## **Proposal for a new series of amendments to UN Regulation No. 116 (Anti-theft and alarm systems)**

### **I. Proposal**

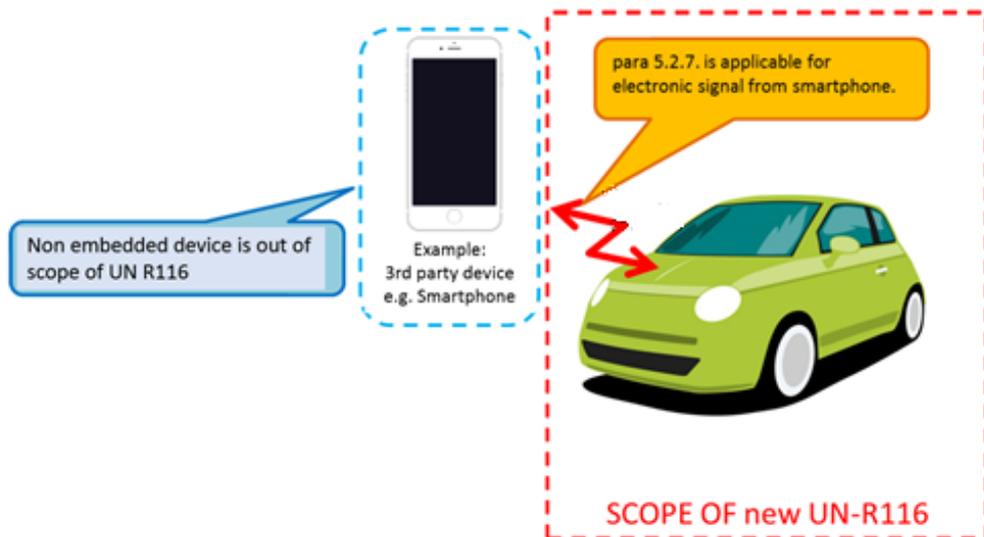
4. According to the current definition of "key", a smartphone cannot be covered as "only by that device". This is the reason why "electronic solution" is added to definition. The hardware (e.g. smartphone) and software transmitting the electronic solution to the vehicle are not in the scope of UN Regulation No. 116. If the electronic solution is defined as a key, it is reasonable that the electronic solution transmitted from the hardware fulfils the requirements of paragraph 5.2.7. (Electrical/electronic locking systems - See figure below).
